**ALERT SERVICE BULLETIN**

NO. 205-10-103  
DATE Jan 11, 2010  
PAGE 1 of 7

**MODEL AFFECTED:** 205A & 205A1

**SUBJECT:** Inspection of Transmission Oil Line P/N 70-061L000V360A for Correct Length.

FIGURE 1

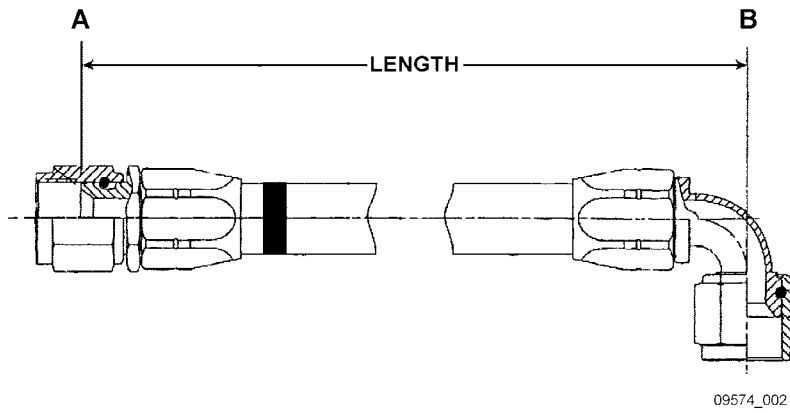
6. Lay the Hose Assembly on a flat surface and measure the length of the Hose as detailed in Figure 1.
7. If the part number 70-061L000V360A Hose Assembly is 36.5 inches (92.71 cm) to 37.5 inches (95.25 cm) then the Hose Assembly must be re-identified, as detailed in step 8.

9. If the Hose Assembly part number 70-061L000V360A measures less than 36.5 inches (92.71 cm) it must be replaced by new part number 70-061L000V370A Hose Assembly prior to further flight.
10. Hoses measuring more than 37.5 inches (95.25 cm) must be replaced by new part number 70-061L000V370A Hose Assembly prior to further flight.
11. Re-install the Hose Assembly and ensure there is no fowling between the Hose Assembly and any airframe components, drive system components, and wiring on the aircraft. See Figure 2 and view "A" for the correct routing of the Hose Assembly.

FIGURE 2

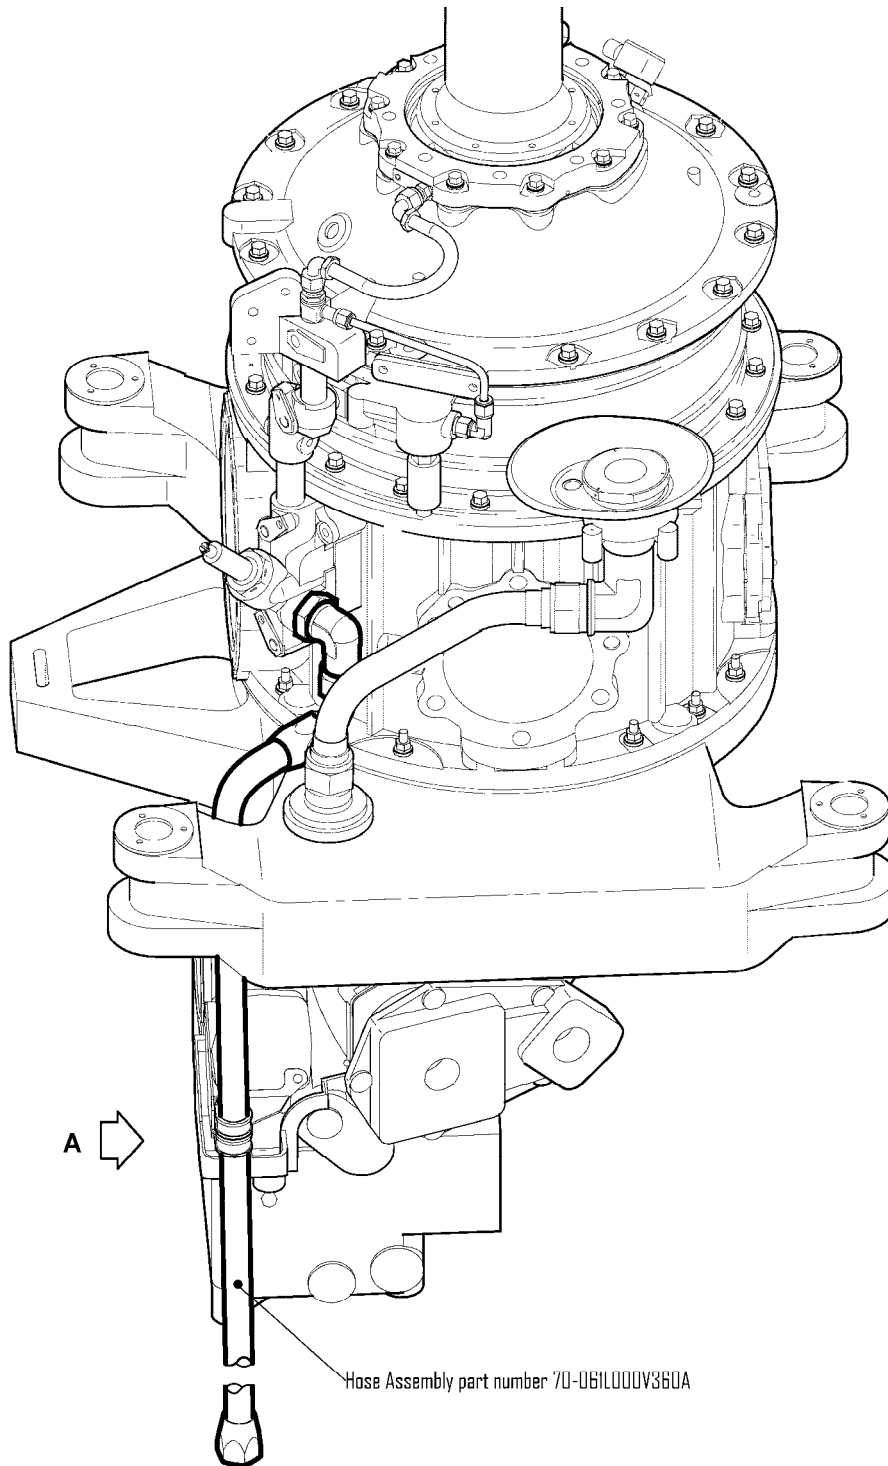
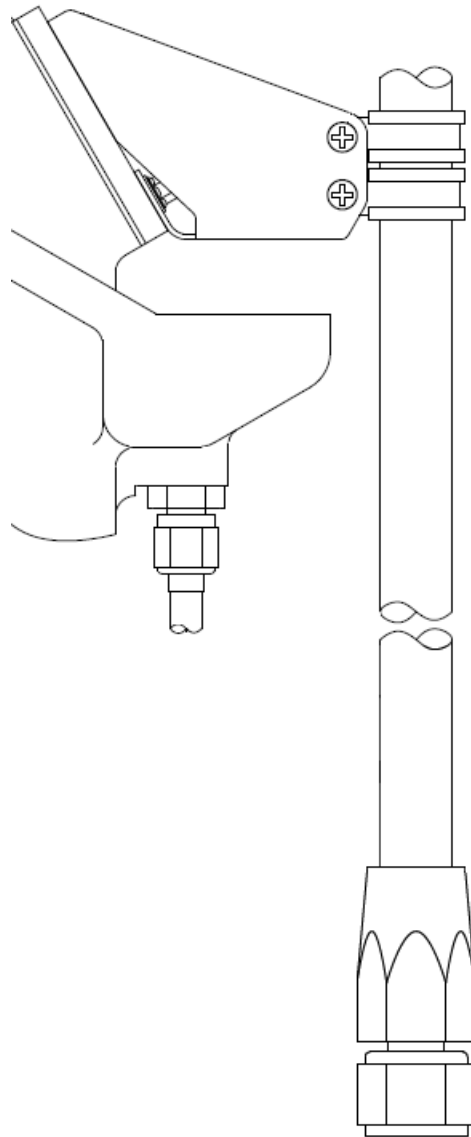
Failure to properly install, align and torque the transmission Hose Assembly could lead to the loss of transmission lubricating oil.
